## Hempsted Lane, Gloucester [20/00315/OUT]

Project:	CRM.1132.021.HY.R.002.A - Outline Drainage Strategy
For:	Gladman Developments Ltd
Status:	Issued
Date:	11 <sup>th</sup> August 2022
Author:	Daniel Alstead BSc [Hons], MSc, MCIWEM, C.WEM - Associate Director
Approver:	Matt Travis BSc [Hons], MSc, MCIWEM, C.WEM, CEnv, CSci - Company Director

## Hempsted Lane, Gloucester, GL2 5DB - LLFA Response Letter

DRAWING TITLE:  
**Proposed Drainage**

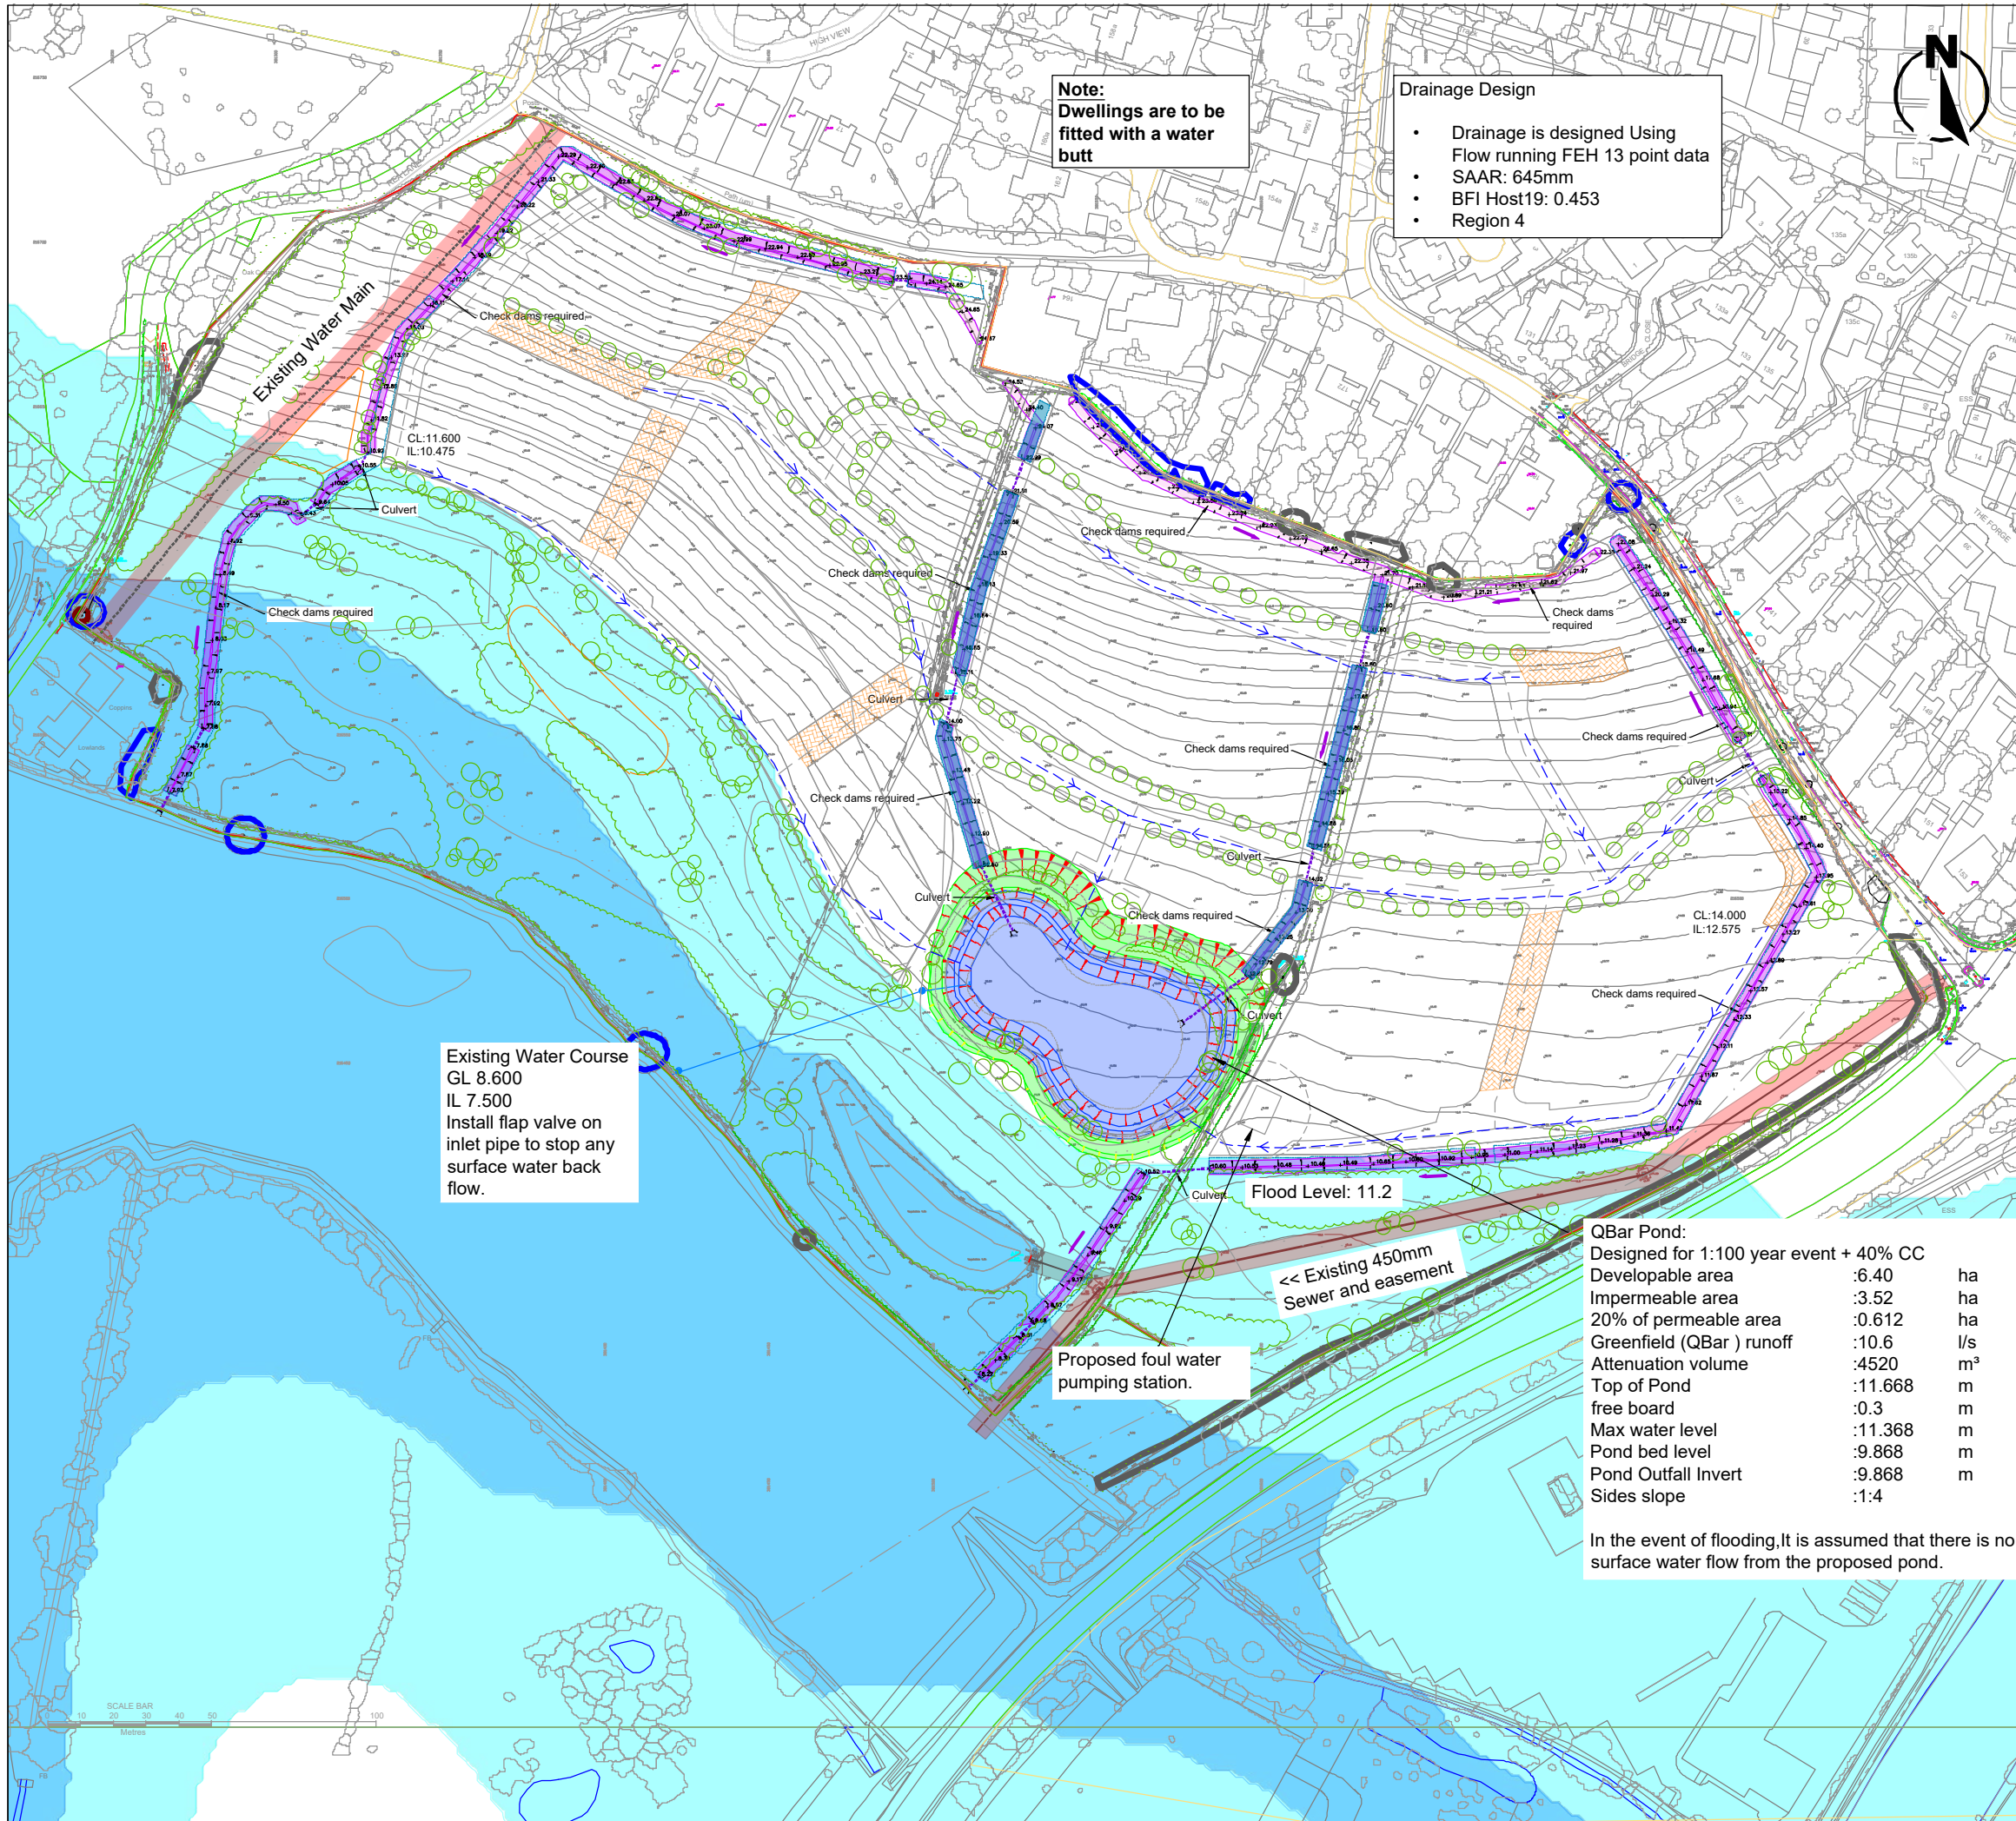
In order to make the design acceptable, the basin will need to occupy a larger footprint than currently shown. If there is confidence that there is space to accommodate this increase in basin size, and still deliver the number of units proposed, then the modifications can be dealt with at detailed design stage. Otherwise, revised proposals should be submitted prior to determination.

Sections have been provided, but additional information is sought. Revised sections have been provided. I am not satisfied that the basin is safe.

Additional section information is required to provide clarity here. As set out above, I am not satisfied that the basin design is safe

The detention basin has been designed with a 1:4 side slope, 1.50m water depth [incorporating a 1.50m safety bench at 0.60m below top of water level], 0.30m freeboard allowance for safety, and 3.50m maintenance bench.

P08	28/07/22	Basin revised to suit latest LLFA comments	EA	RB	DA
P07	24/06/22	Updated to suit Client comments	EA	EA	DA
P06	22/06/22	Updated to suit latest LLFA comments	EA	DA	DA
P05	06/04/22	Updated with latest DFP	EA	MT	MT
P04	29/03/22	Pond re-sized to suit LLFA comments, swales and indicative SW routes added	EA	DA	DA
P03	25/11/19	Pond re-sized to suit latest DFP	WW	SM	EC
P02	20/09/19	Amended to suit developable area	SM	MGg	BF
P01	22/07/19	First Issue	SM	MGg	BF
REV:	DATE:	DETAIL:	DES:	CHK:	APP:
